PROJECT TITLE  
**Domremy College Solais Project**

### STORMWATER MANAGMENT CONCEPT PLAN – CIVIL ENGINEERING

## **RE: DA2018/0076 DOMREMY COLLEGE: RESPONSE TO REQUEST FOR ADDITIONAL INFORMATION**

**RE: DOMREMY CATHOLIC COLLEGE - 121 FIRST AVENUE, FIVEDOCK (DA 2018/0076)  
LETTER OF RESPONSE TO COUNCIL**

## Attachment 2

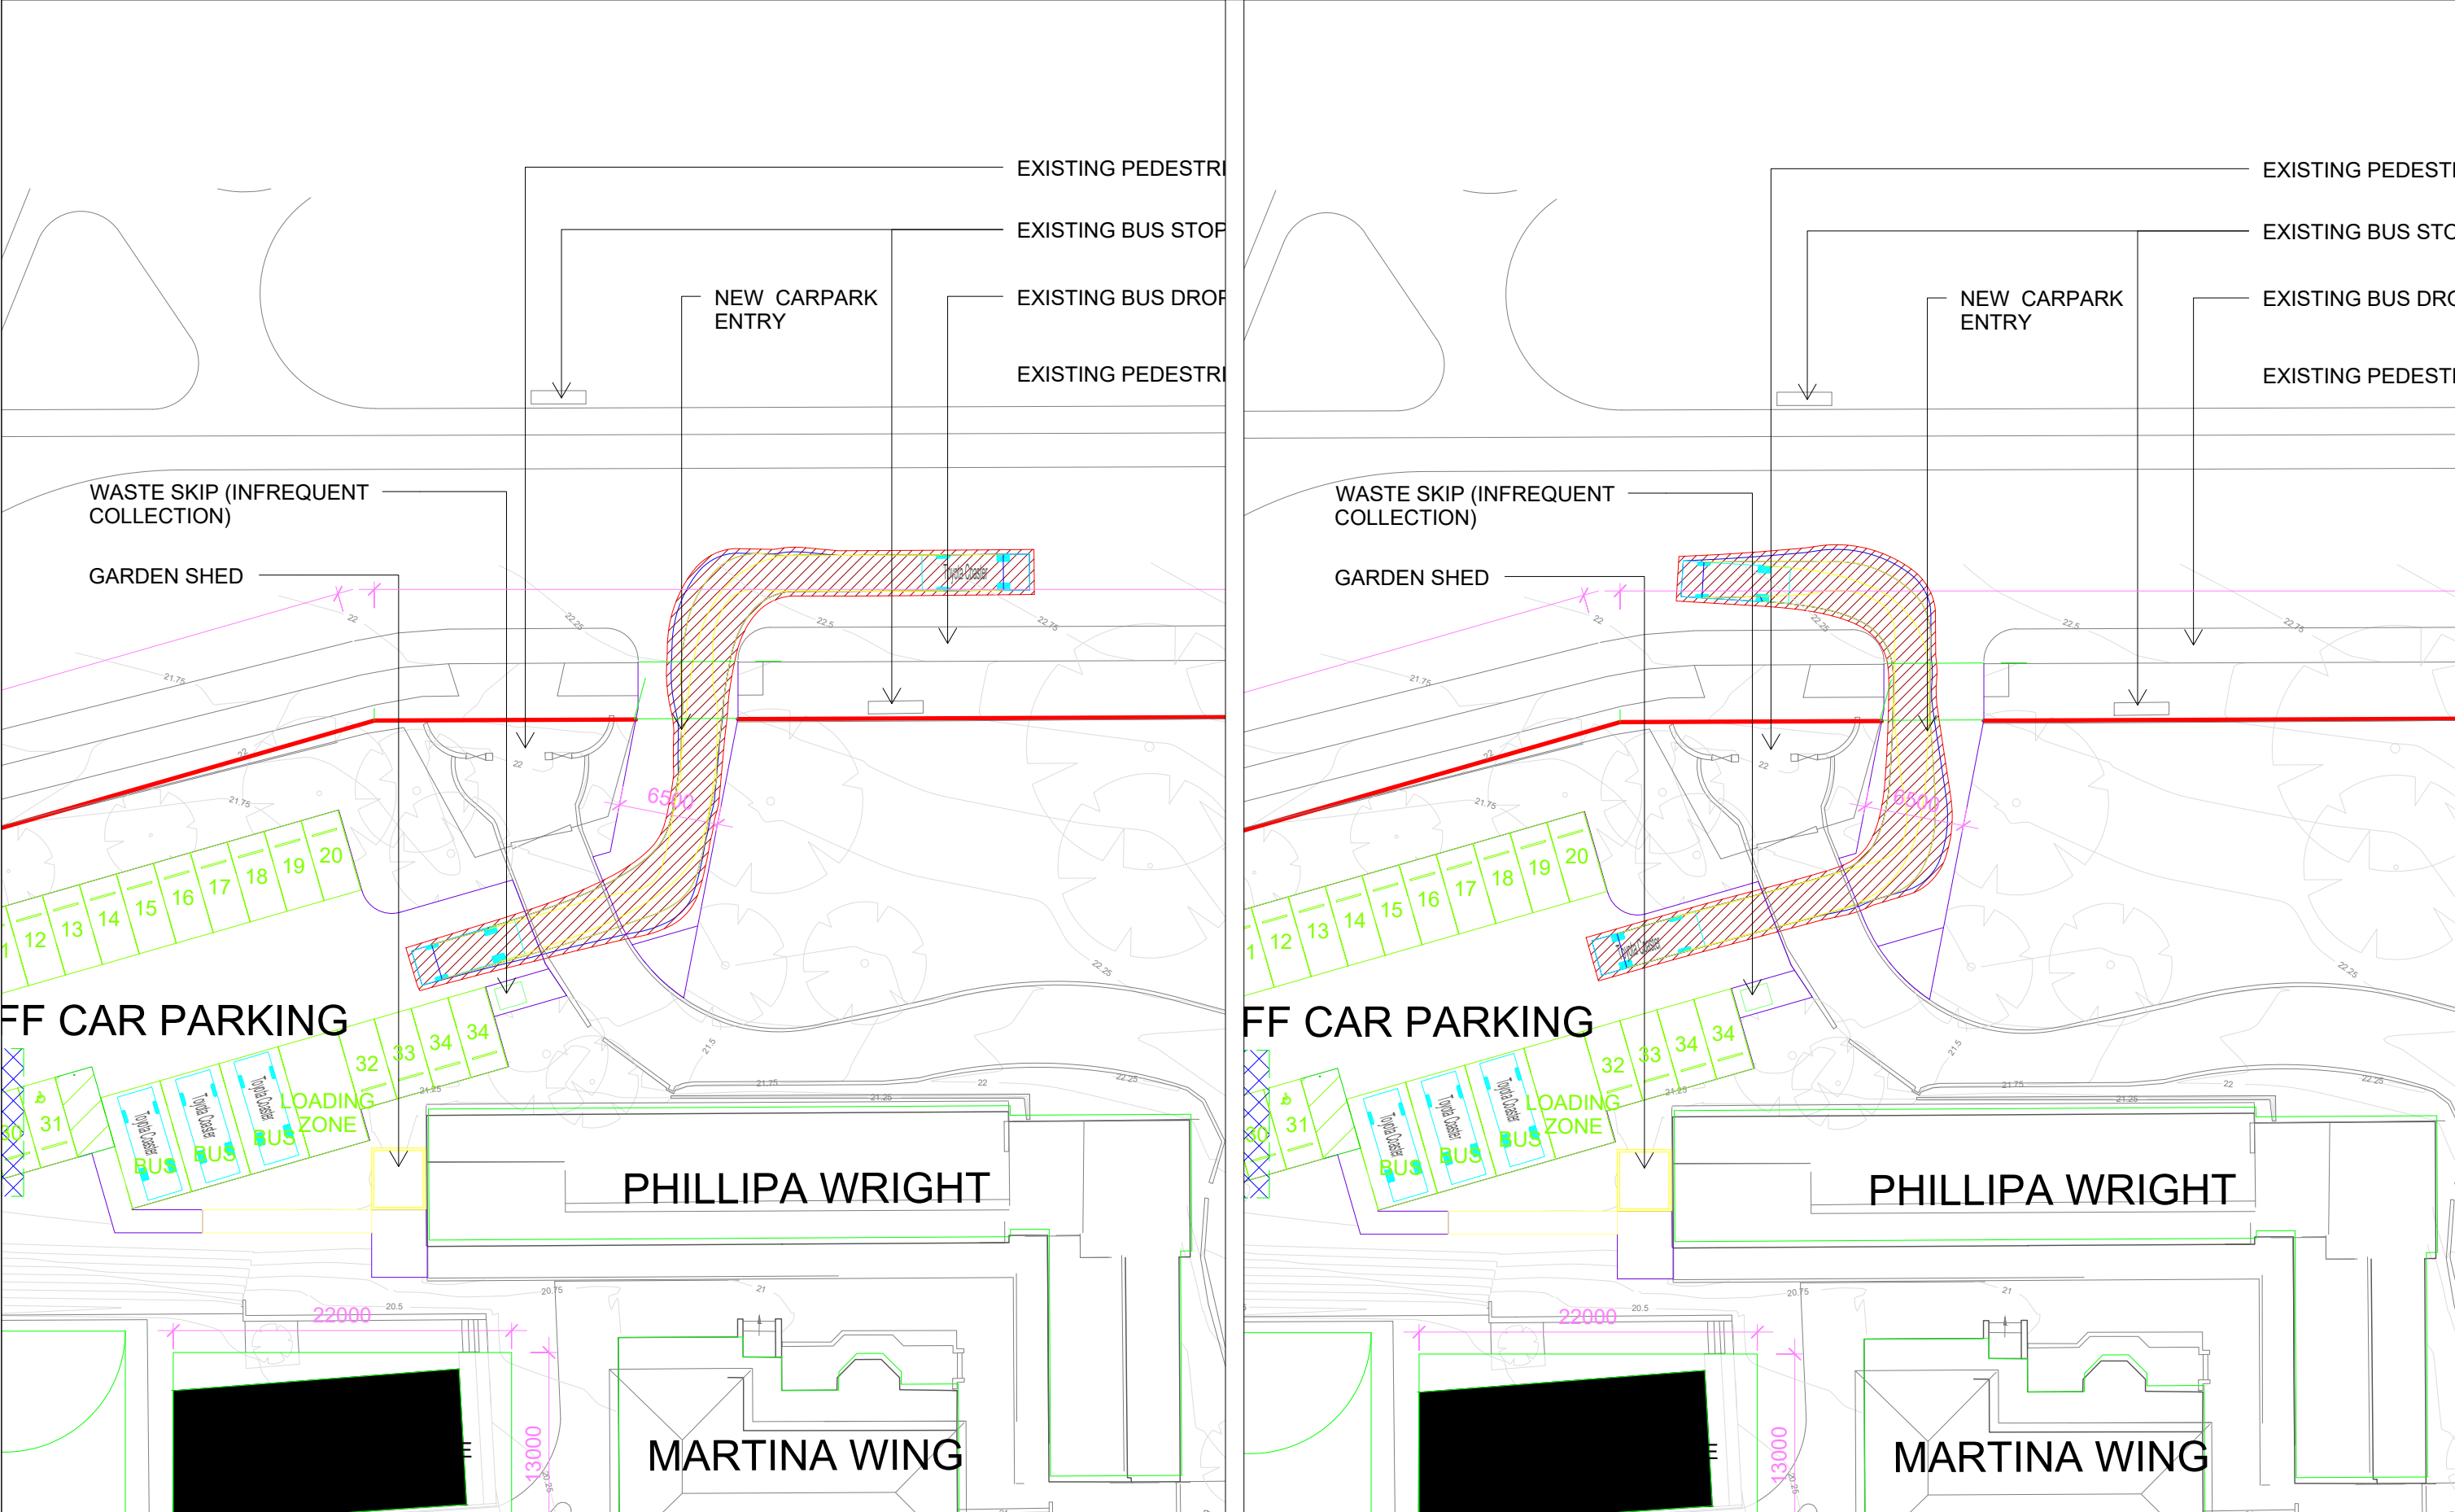
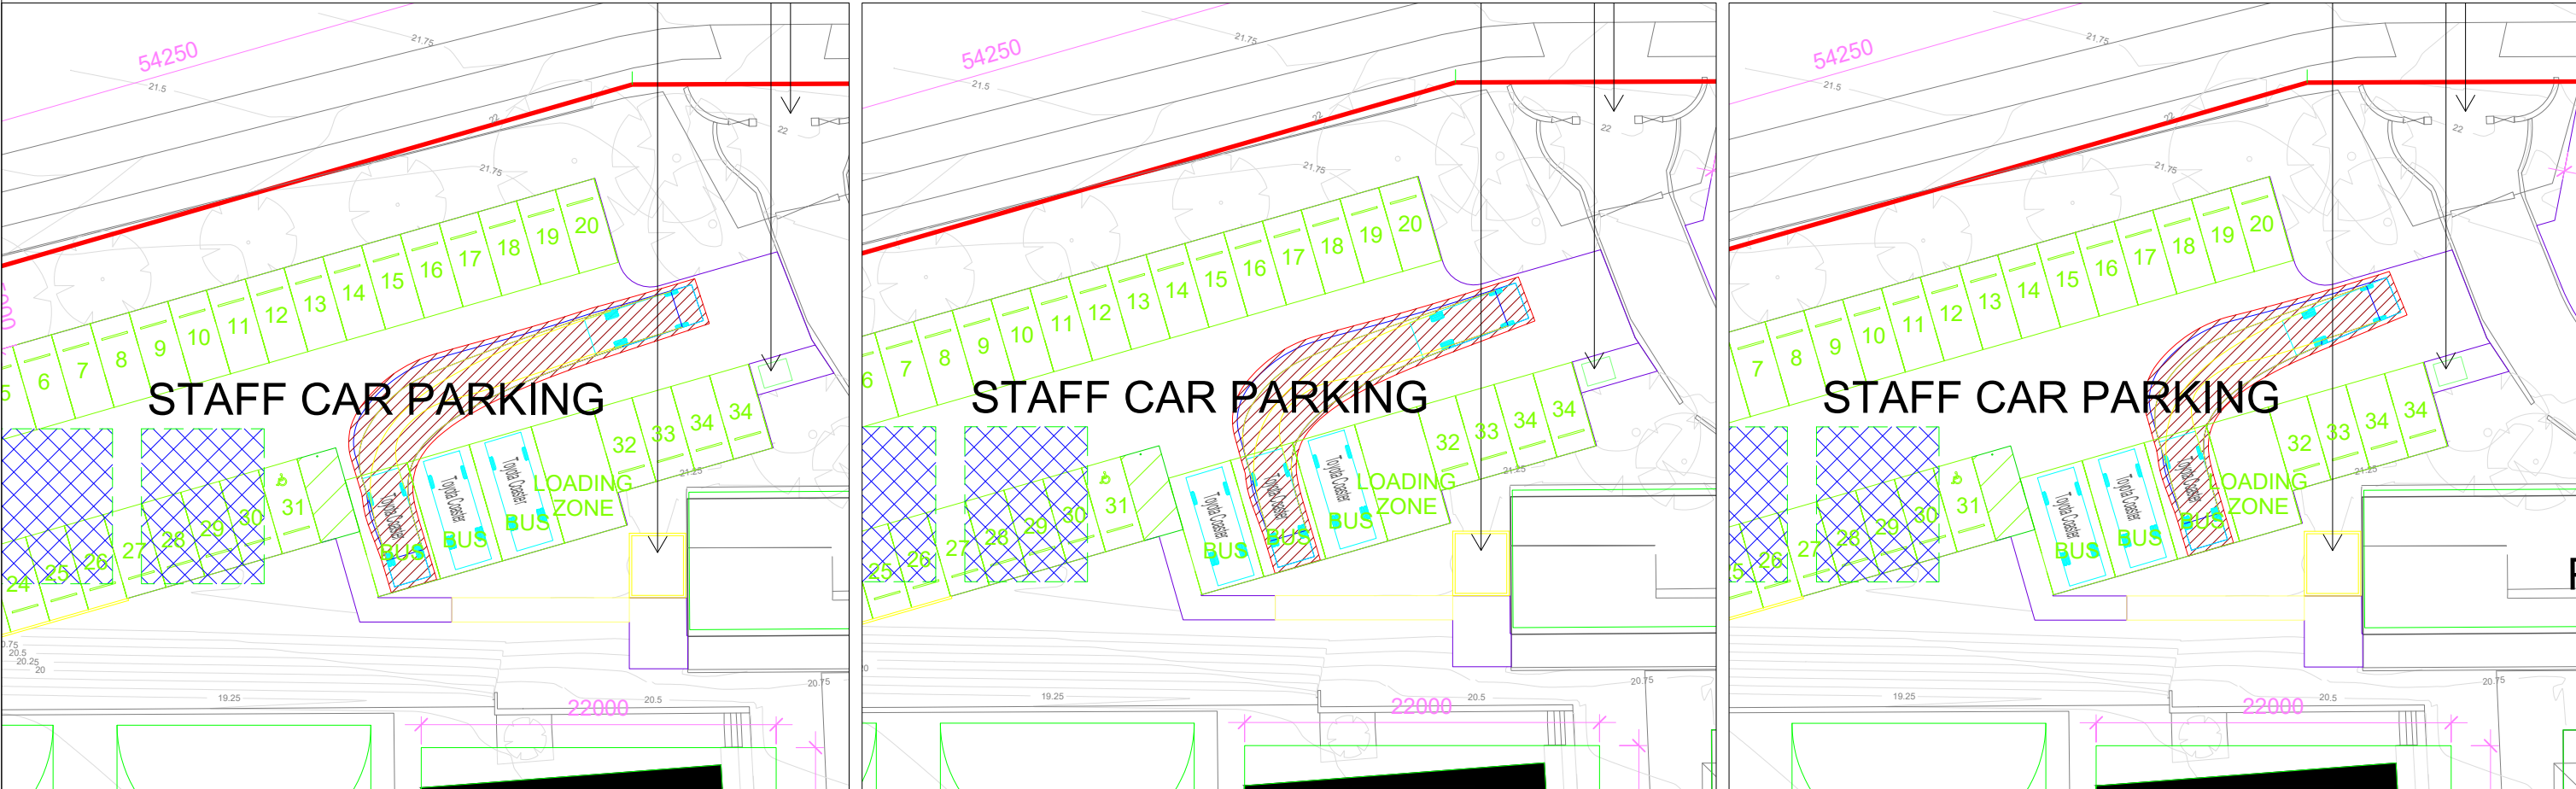
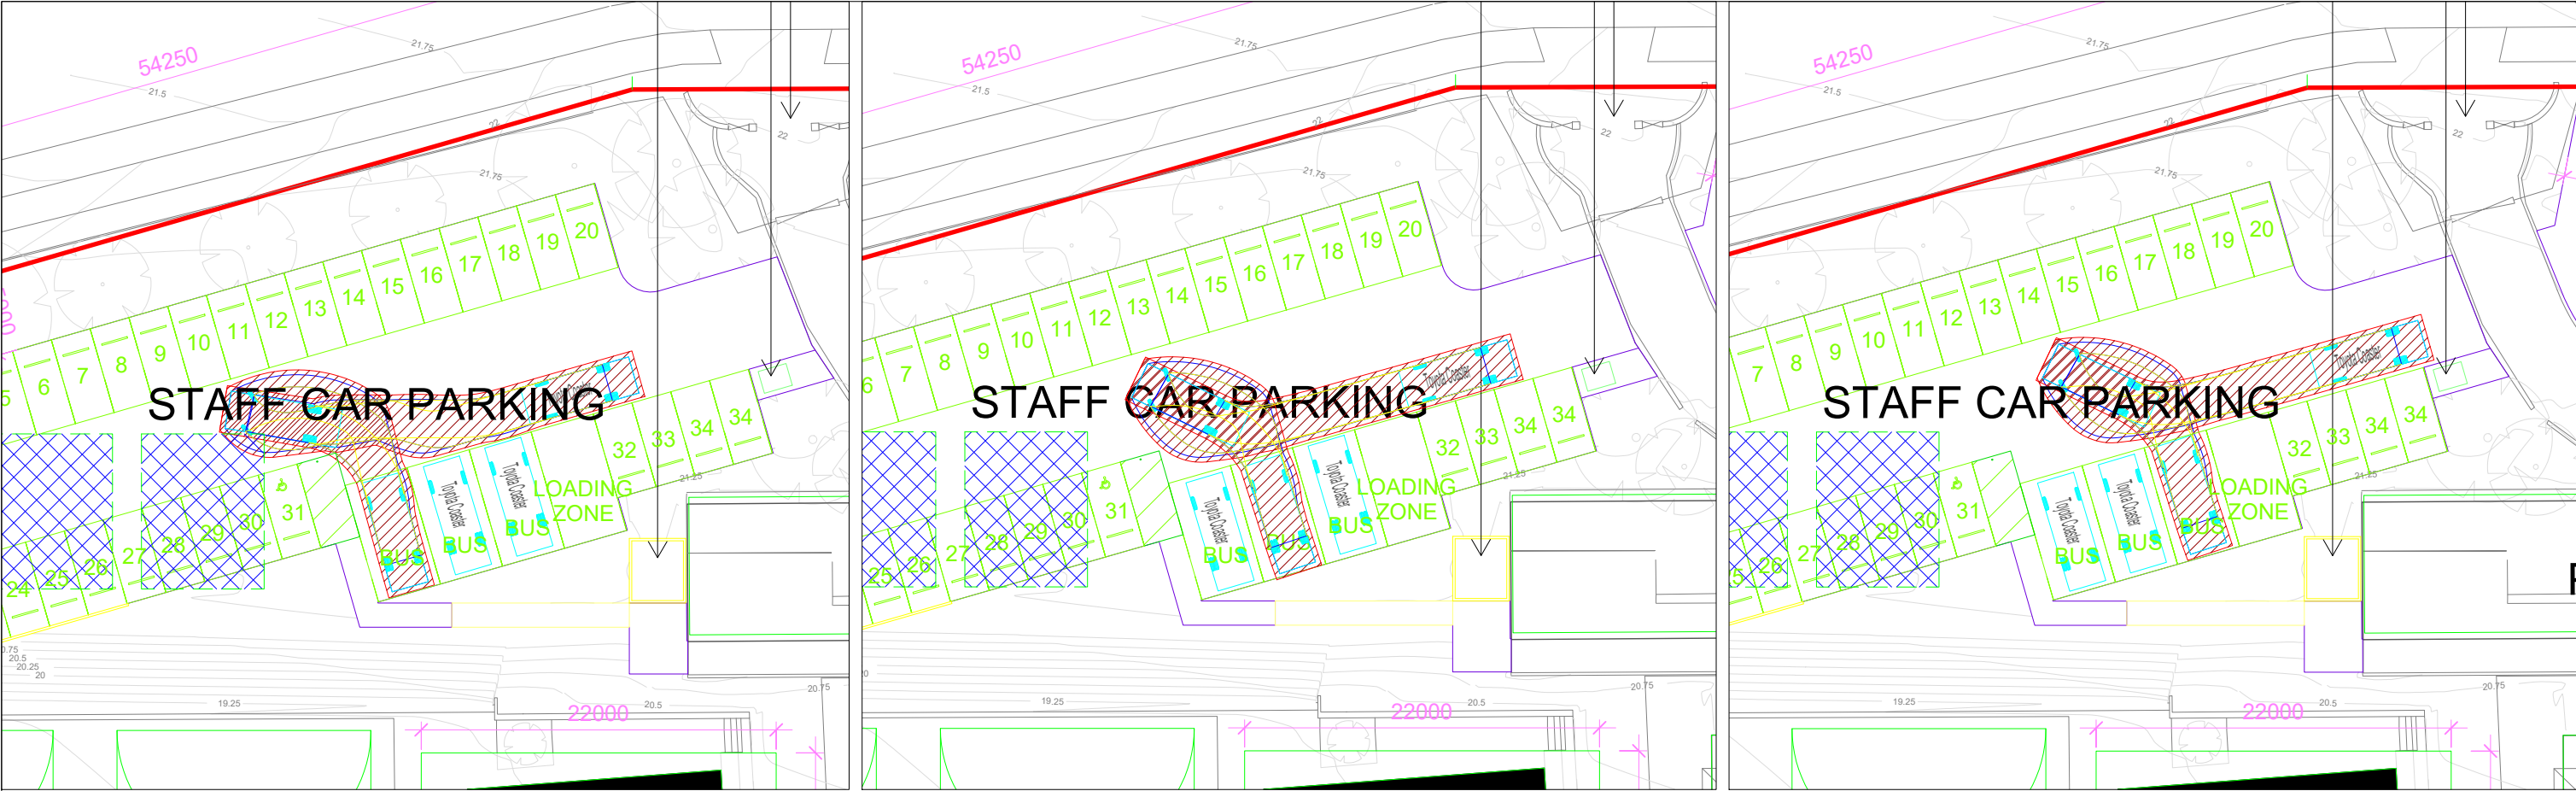
The revised arrangements have also been assessed using swept path analysis for a 7.6 metre Toyota Coaster and 8.8 metre Medium Rigid Vehicle (MRV). The results are included in **Attachment 2** and confirm that satisfactory entry and exit movements will be achieved, clear of Tree 38. We do however note that access by an 8.8 metre MRV will only be permitted outside of school hours when the car park is vacant. This will ensure that there is ample space for an 8.8 metre MRV to turn around on-site as demonstrated by the swept path results.
